SEP BIOSOLIDS

CDR PHASE 3 UPDATE

APRIL 2021

CDR PHASE 3 CONTINGENCIES

JERROLD STREETSCAPE - PROPOSED SCHEME

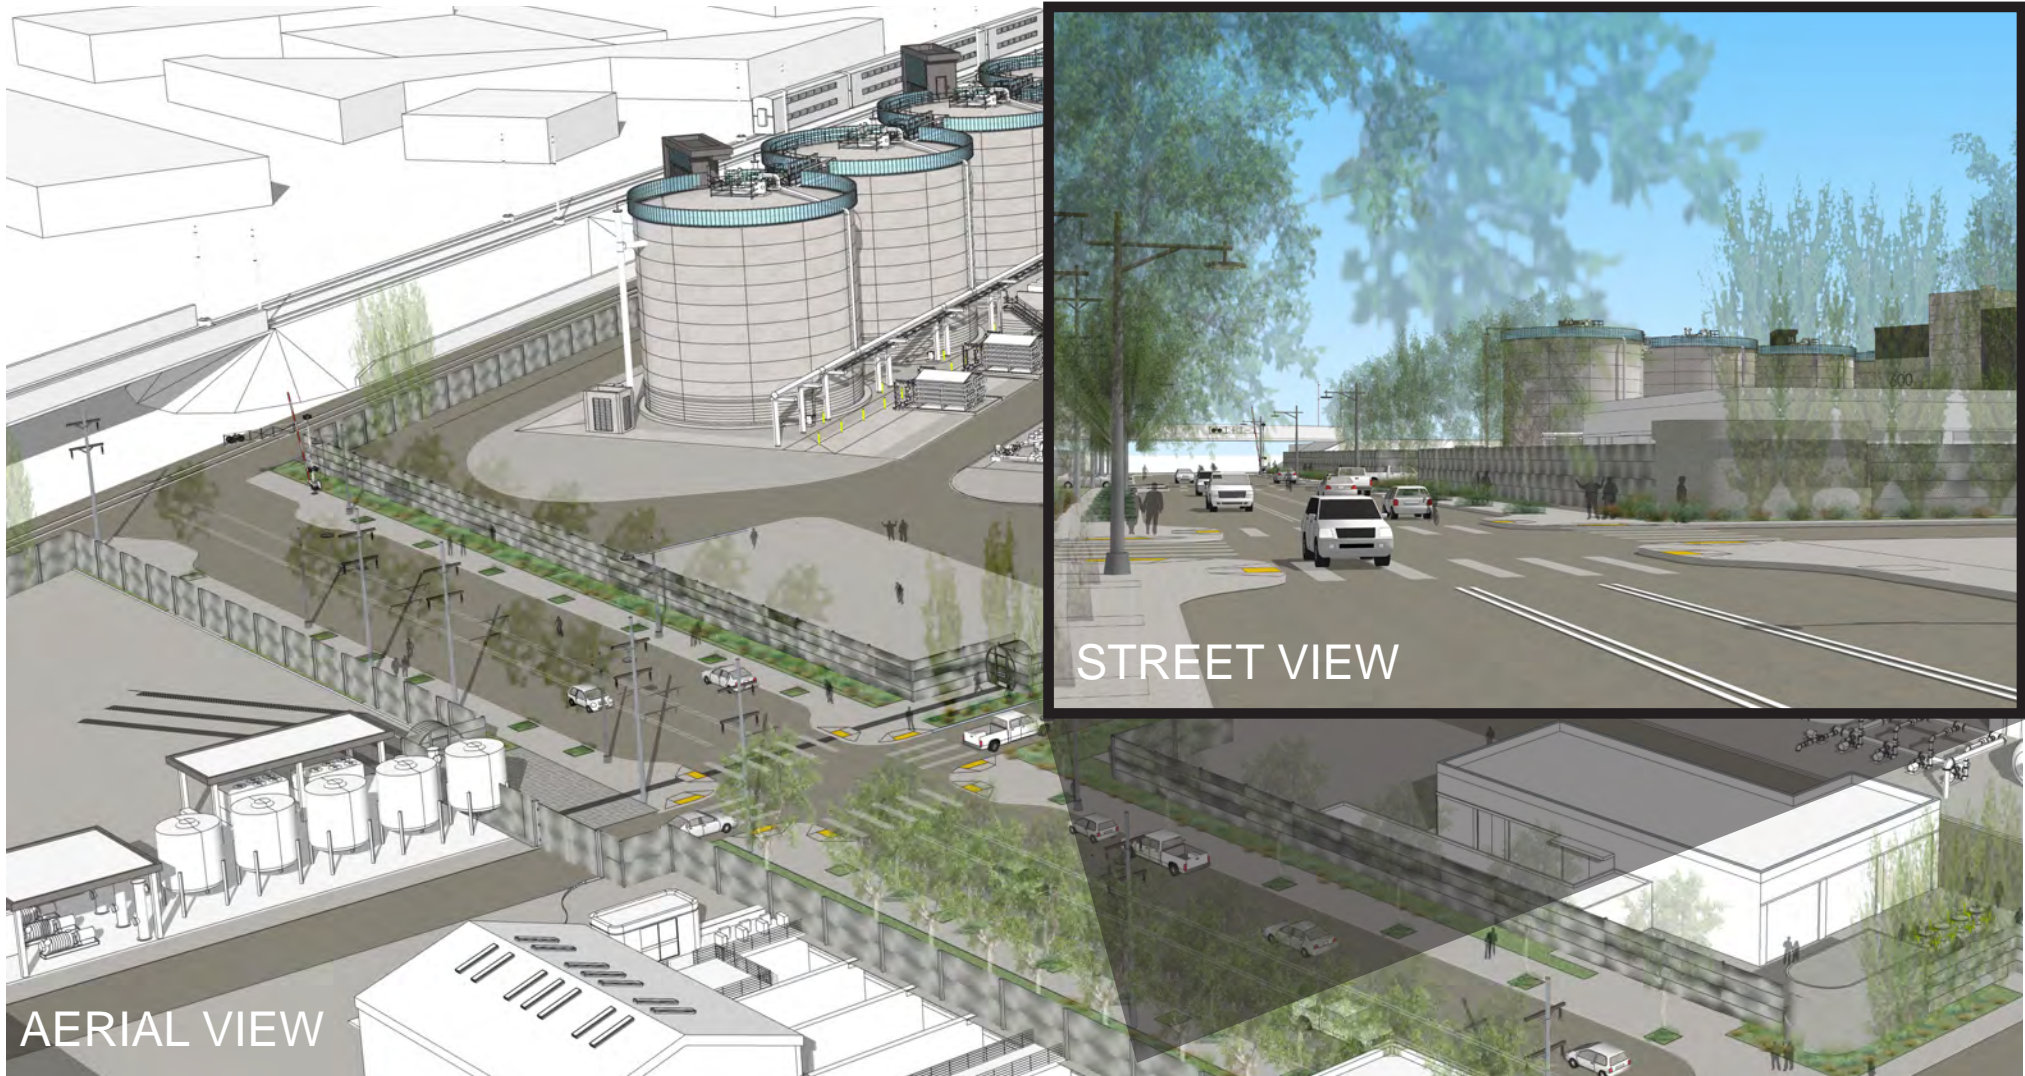
CDR Phase 3 Comment:

Simplify fence accent panels approach.
